February 19, 2008

Subject: Comments on City of Portland's Request for Permission to Experiment with a
Bicycle Box and Colored Bicycle Lane Intersection Treatment

Photo: At the Frontiers of Cycling: Policy Innovations in the Netherlands, Denmark, and Germany; Annotation: Robert M Shanteau

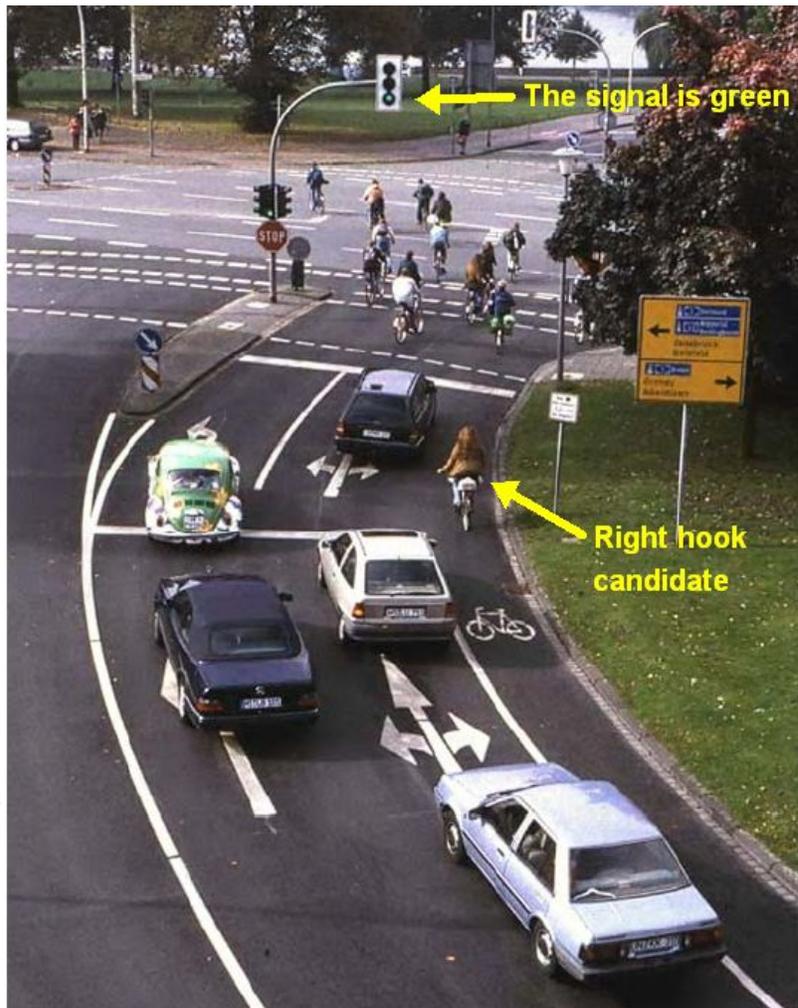
This practice exposes bicyclists to right hook accidents during the signal's 'green' phase. The application states that this problem can be addressed "by striping colored bicycle lanes into the intersection and thus identifying the area of potential conflict during the signal's 'green' phase." Such an expectation is unrealistic and places a bicyclist in the bicycle lane in danger of being right hooked.

This problem is illustrated in a photograph on the cover of a report entitled *At the Frontiers of Cycling: Policy Innovations in the Netherlands, Denmark, and Germany* <<http://www.eco-logica.co.uk/pdf/wtpp13.3.pdf>>. I have reproduced the photograph here, but I have added annotation illustrating that the right hook problem still exists for bicycle boxes when the signal is green.

Figure 9C-5. Example of Pavement Markings for Bicycle Lanes on a Two-Way Street

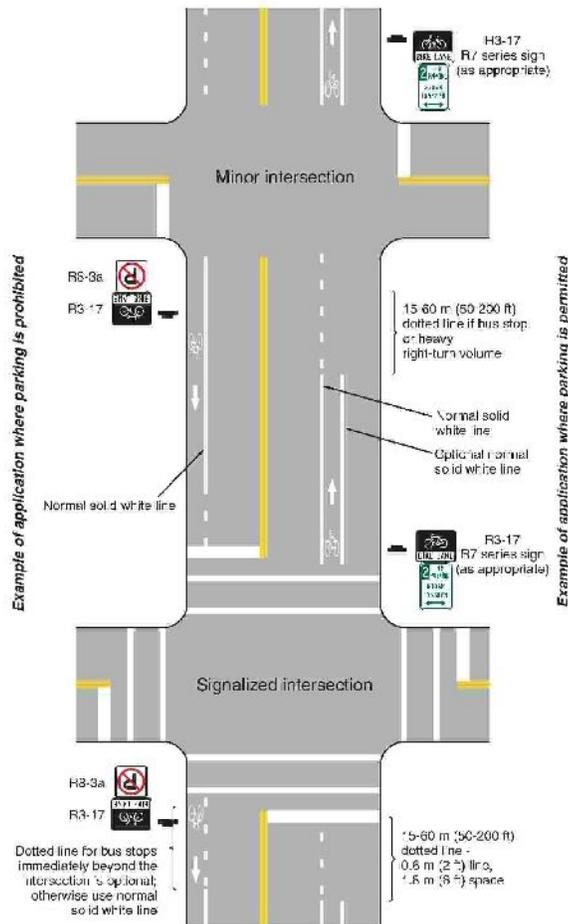
1975 and available online at <http://rmshant.googlepages.com/SCR47Report.pdf>. The SCR 47 Committee report recommended that motorists be required to merge into bicycle lanes before turning right. Shortly thereafter, I and others recommended that bicycle lane stripes be broken before intersections in order to

encourage turning motorists to make the merge. This guidance was subsequently incorporated into the Caltrans Highway Design Manual, the AASHTO Guide for the Development of Bicycle Facilities and now Figure 9C-5 of the MUTCD, shown at right.

Figure 39: Effective radius at intersections is increased with bike lanes
 Source: Oregon Bicycle and Pedestrian Plan

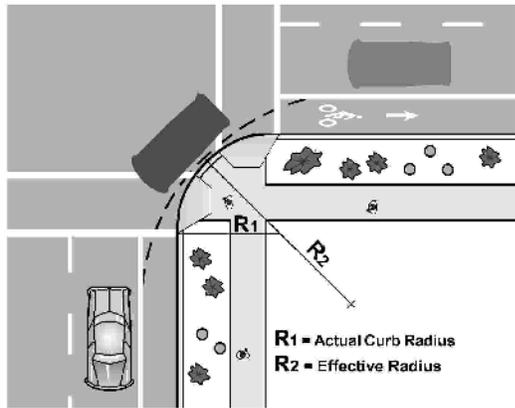
In Oregon, motorists are prohibited from merging into bicycle lanes (ORS 811.435, 814.210, and 811.440) and bicycle lanes are striped solid all the way to the intersection. This striping practice is documented in the Oregon Bicycle and Pedestrian Plan http://egov.oregon.gov/ODOT/HWY/BIKEPED/docs/or_bicycle_ped_plan.pdf, which is apparently contained by reference in the 2003 Oregon Supplement to the MUTCD http://www.oregon.gov/ODOT/HWY/TRAFFIC-ROADWAY/docs/pdf/Oregon_Supplement_MUTCD_2003_Edition.pdf by way of this statement in section 9B.04, "The Oregon Bicycle and Pedestrian Plan gives statewide practices and recommendations for providing signs and bicycle lane markings." The problem of striping bicycle lanes solid to the intersection is shown, but not recognized, in Figures 39 (page 85) and 95 (page 126) of the Oregon Bicycle and Pedestrian Plan.

Figure 10. Typical Bicycle and Auto Movements at Major Intersections

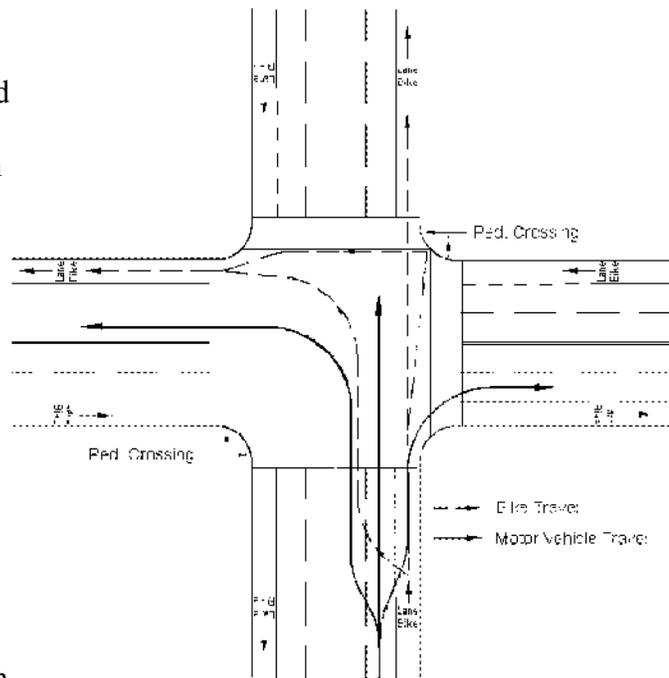
Section 9C.02 of the MUTCD states, "Bikeway design guides should be used when designing markings for bicycle facilities (see Section 9A.05)." The first reference listed in Section 9A.05 is the AASHTO Guide for the Development of Bicycle Facilities. The AASHTO Guide addresses bicycle lane striping at intersections on page 25. It states, "At signalized or stop-controlled intersections with right-turning motor vehicles, the solid striping to the approach should be replaced with a broken line with 0.6-m (2-foot) dots and 1.8-m (6-foot) spaces." It goes on to state, "Bike lanes sometimes complicate bicycle and motor vehicle turning movements at intersections. Because they encourage bicyclists to keep to the right and motorists to keep to the left, both operators are somewhat discouraged from merging in advance of turns. Thus, some bicyclists may begin left turns from the right-side bike lane and some motorists may begin right turns from the left of the bike lane. Both maneuvers are contrary to established rules of the road and may result in conflicts; however, these can be lessened by signing and striping. At intersections, bicyclists proceeding straight through and motorists turning right must cross paths. Striping and signing configurations which encourage crossings in advance of the intersection, in a merging fashion, are preferable to those that force the crossing in the immediate vicinity of the intersection." This guidance is illustrated in Figure 10 of the AASHTO Guide. Thus, the Oregon

practice of forcing the crossing in the immediate vicinity of the intersection by prohibiting motorists from merging into the bicycle lane before turning and striping the bicycle lane solid to the intersection violates the guidance in the AASHTO Guide.
